# BEN FRANKLIN BUILDING

Architect ARB	
Registration No.:	Date: 08.24.2018
Drawn by ARB	
Job Number: 1818	
TITLE SHEET	
SCALE:	1 1/2" = 1'-0"

A0.00

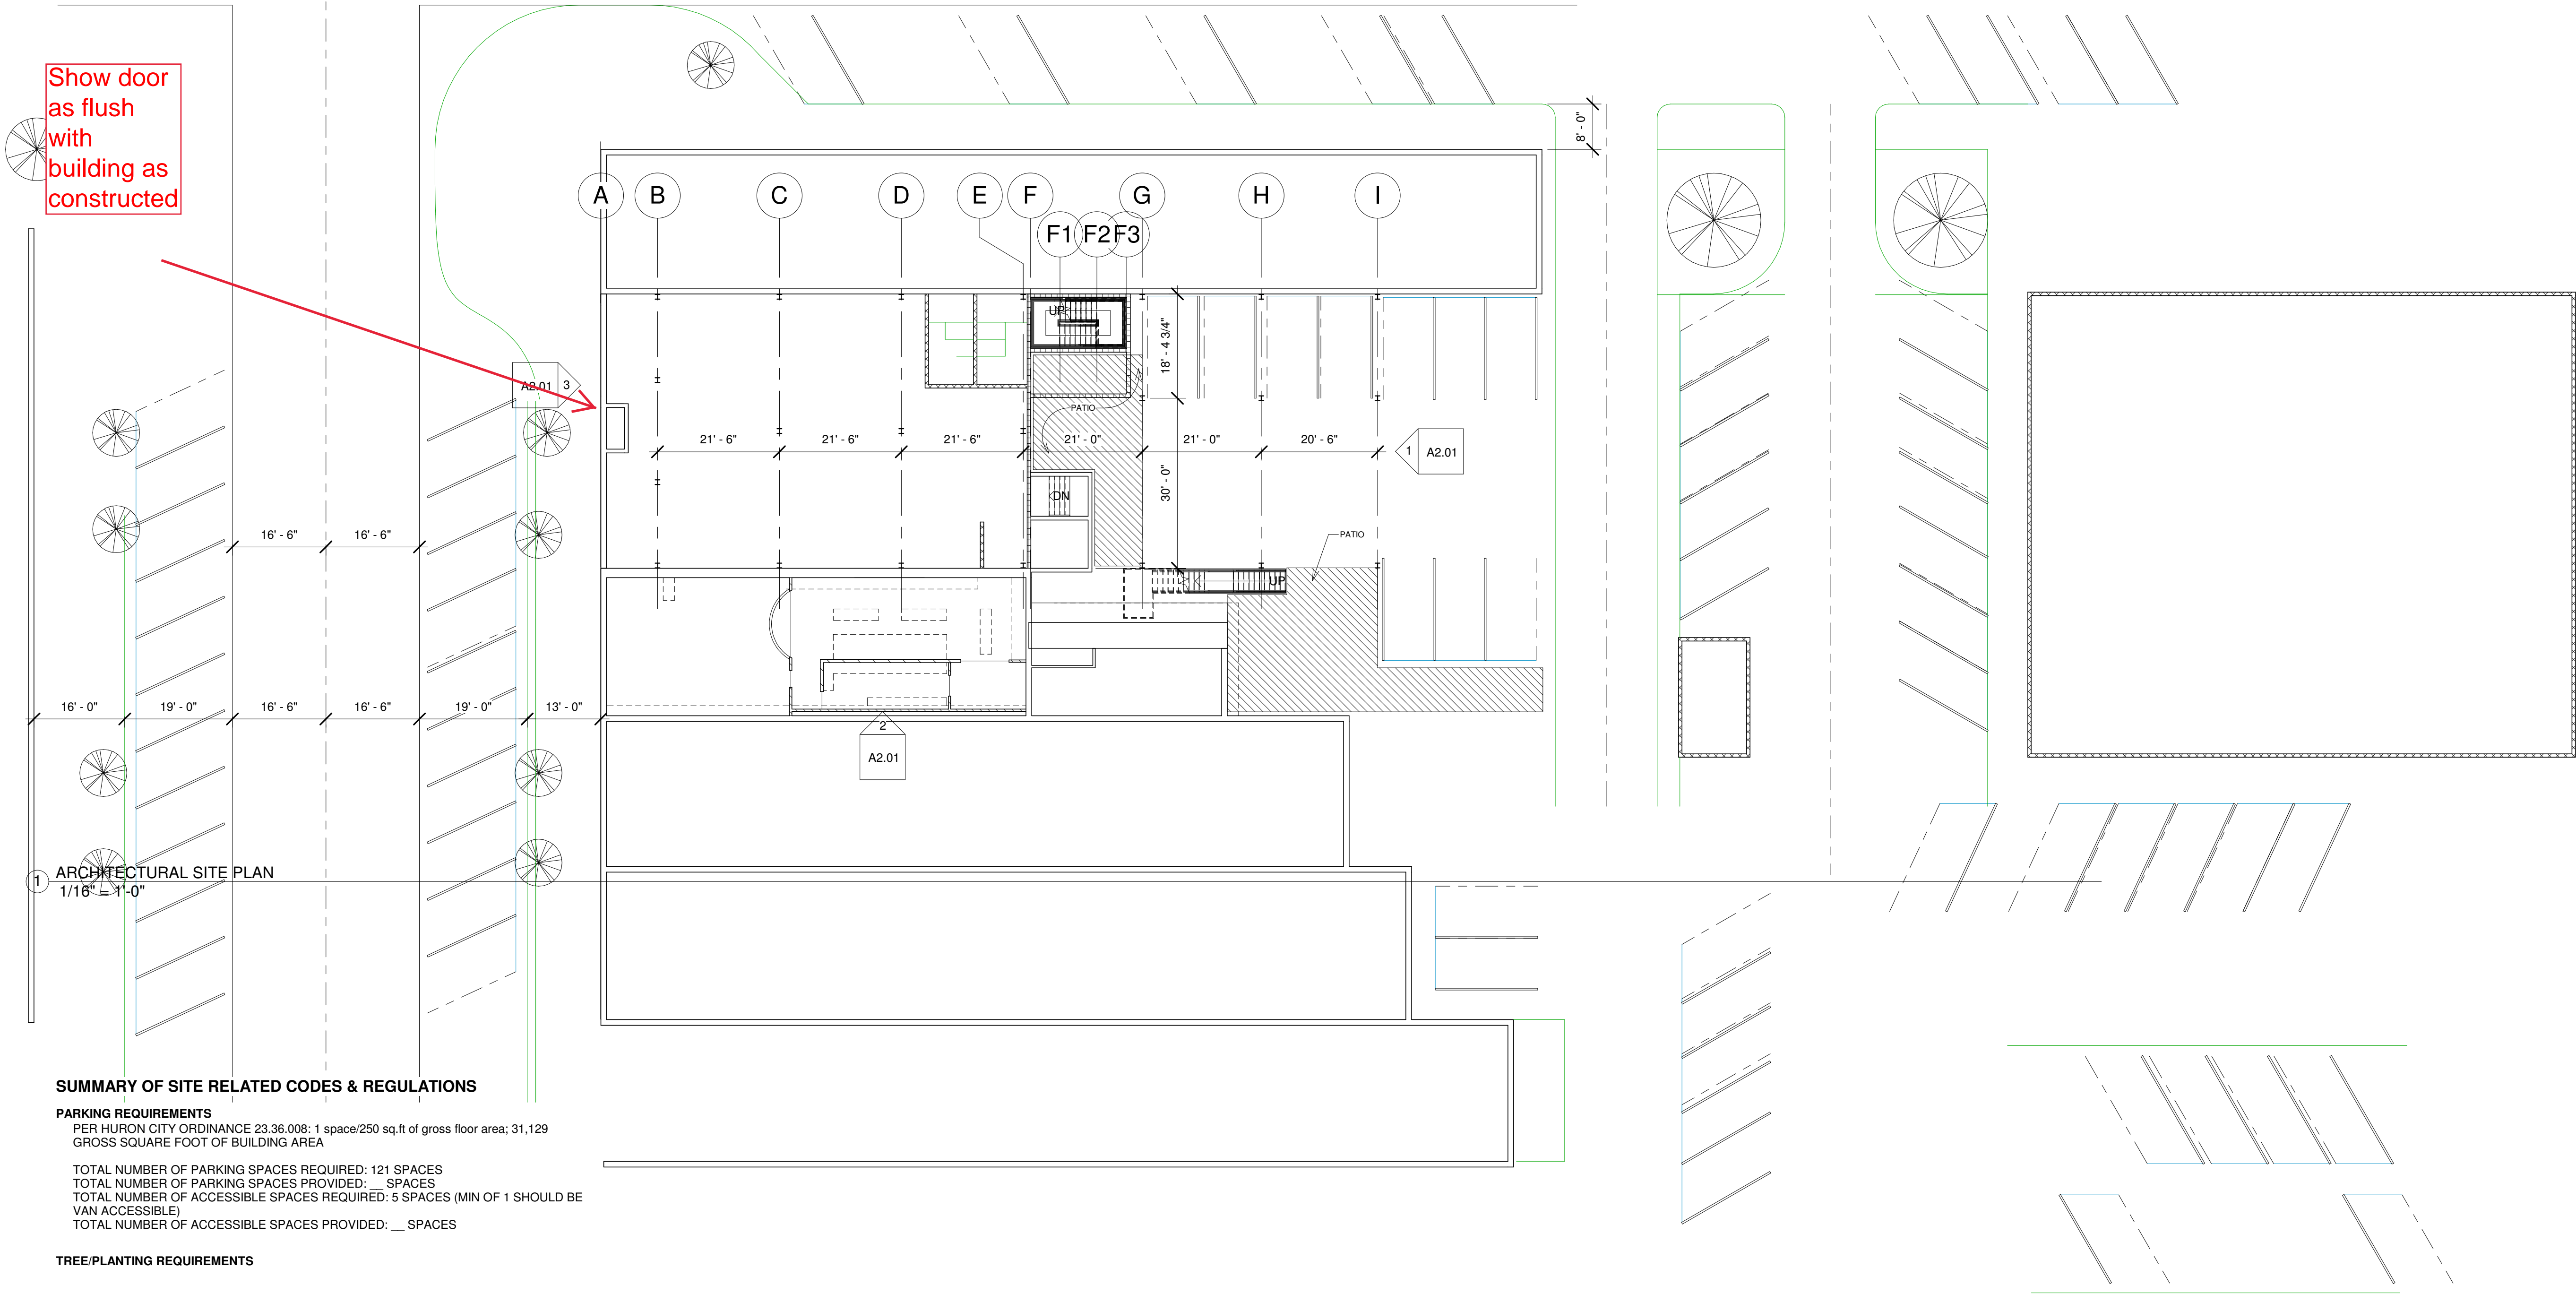
Show door flush with building

Show as constructed with a garage door

Show door as flush with building as constructed

A1.01

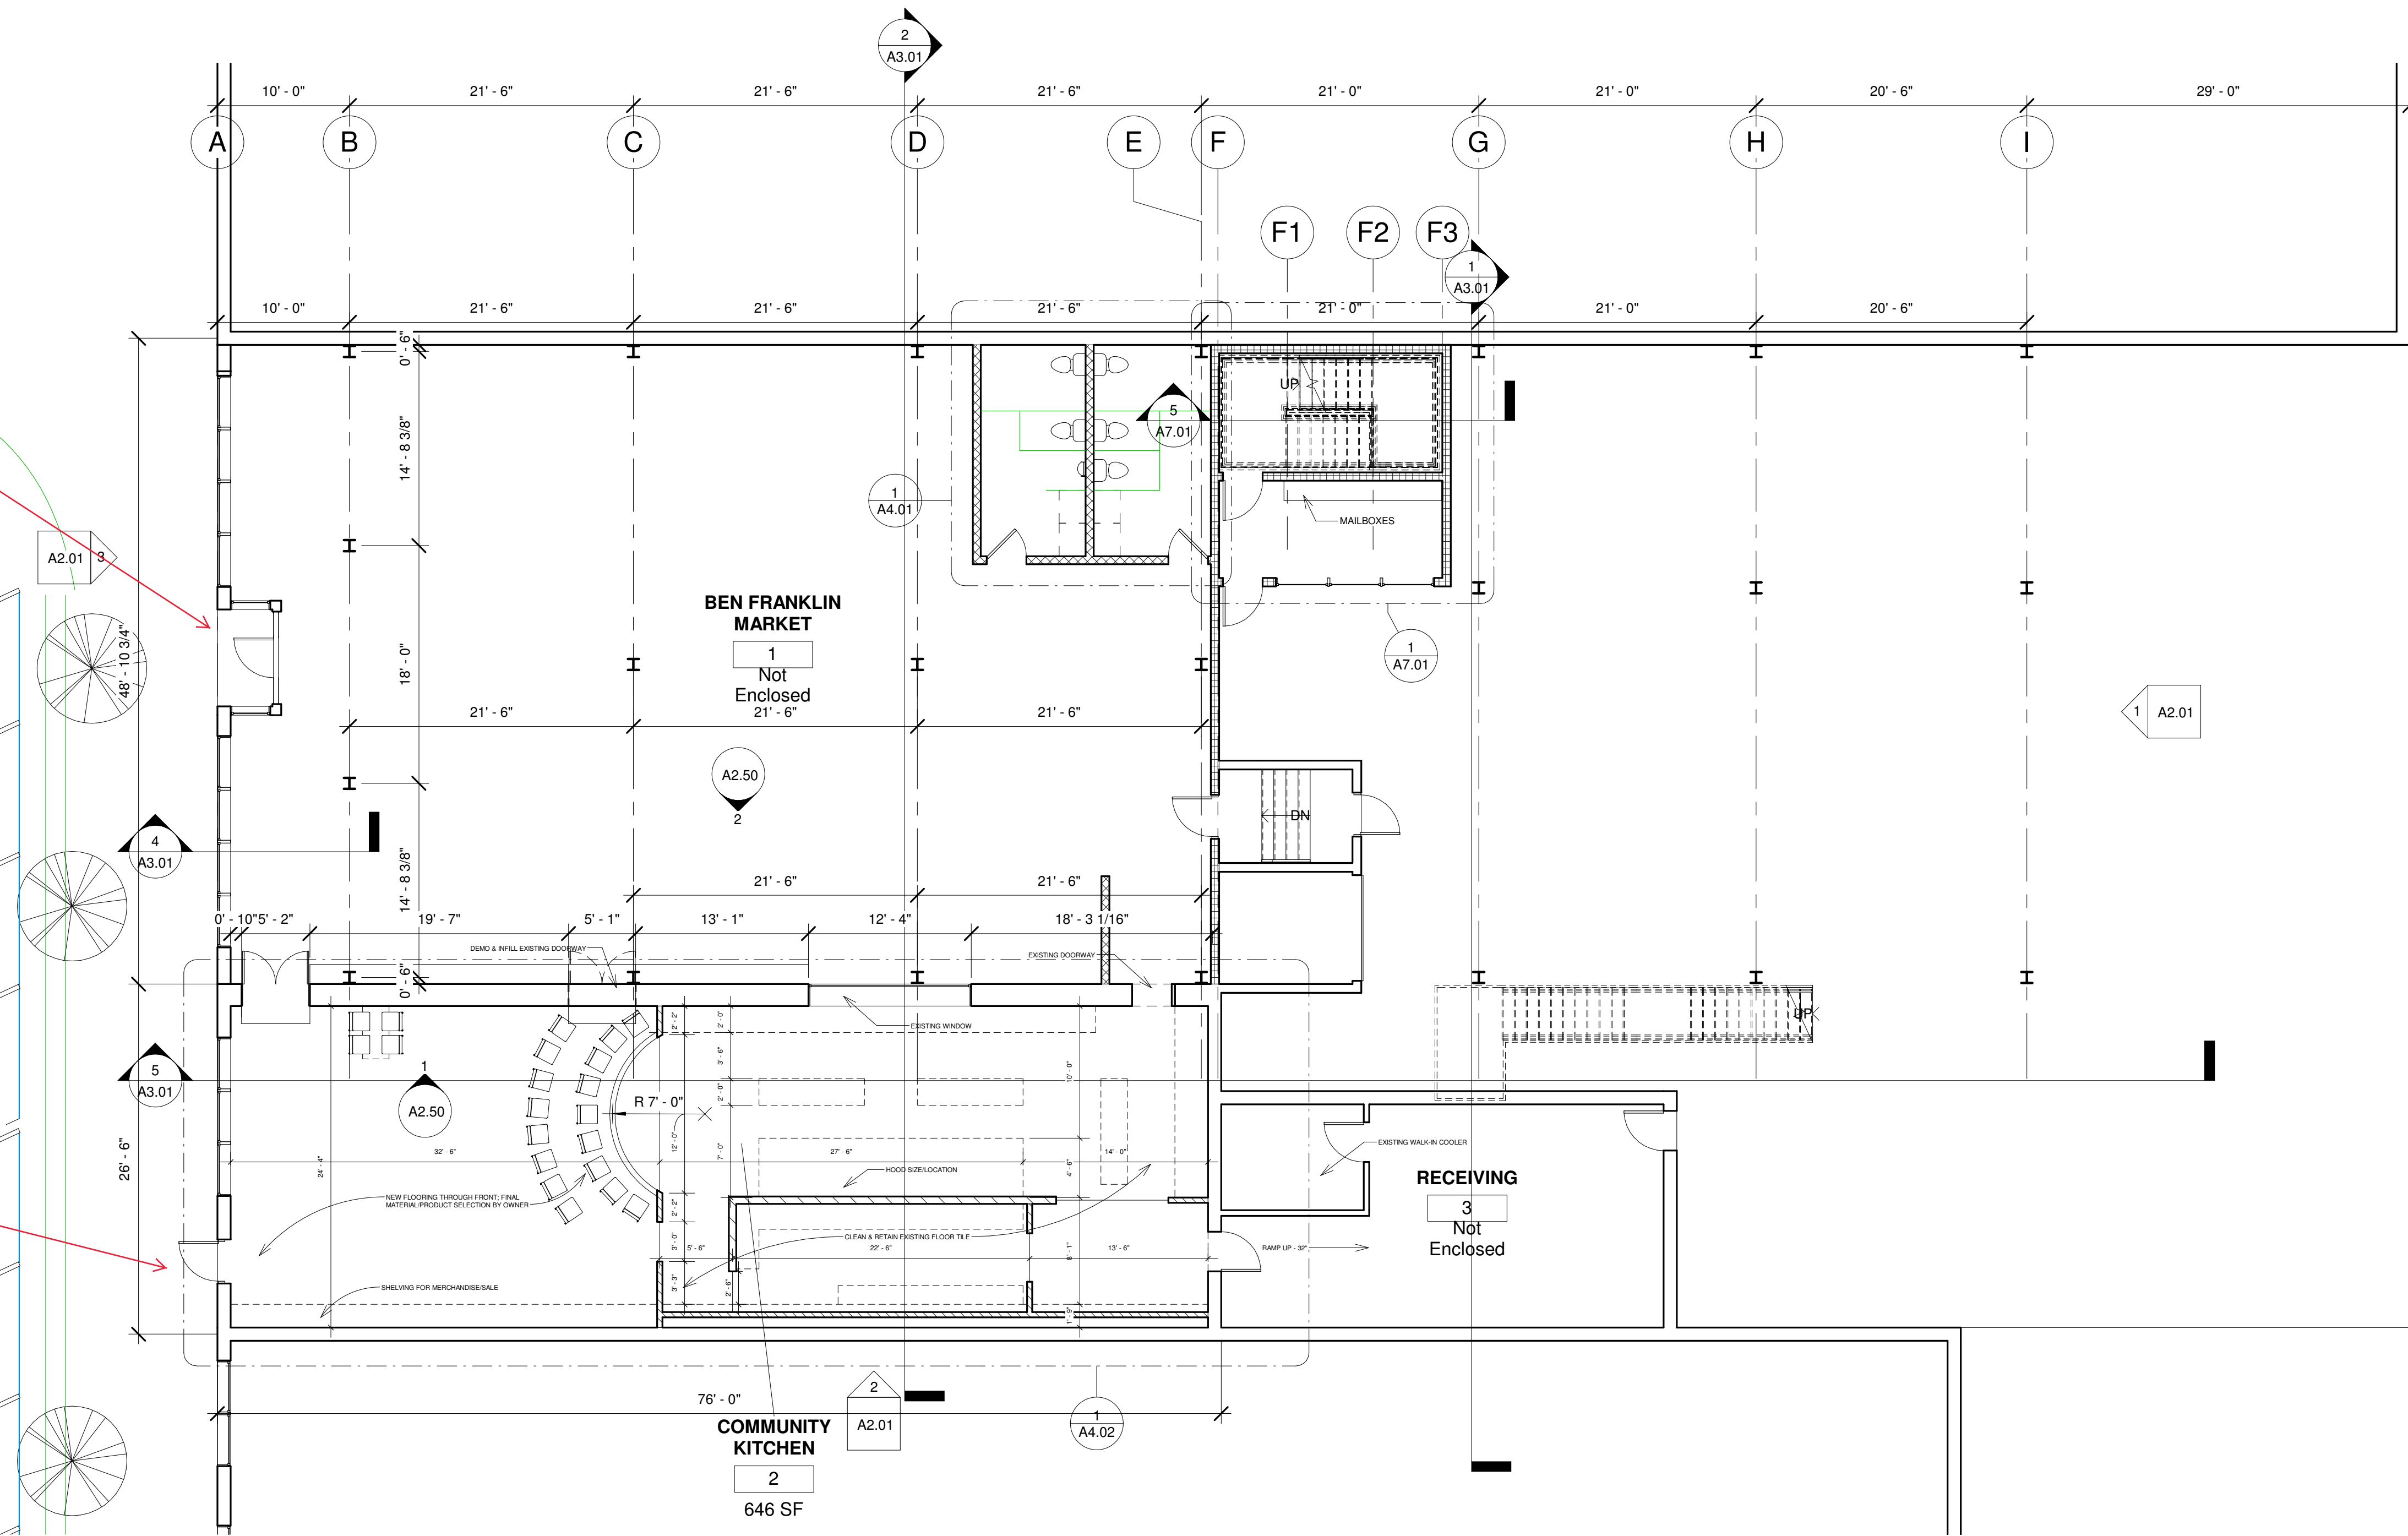
Show as  
constructed  
- Flush with  
building

Change to  
Garage door
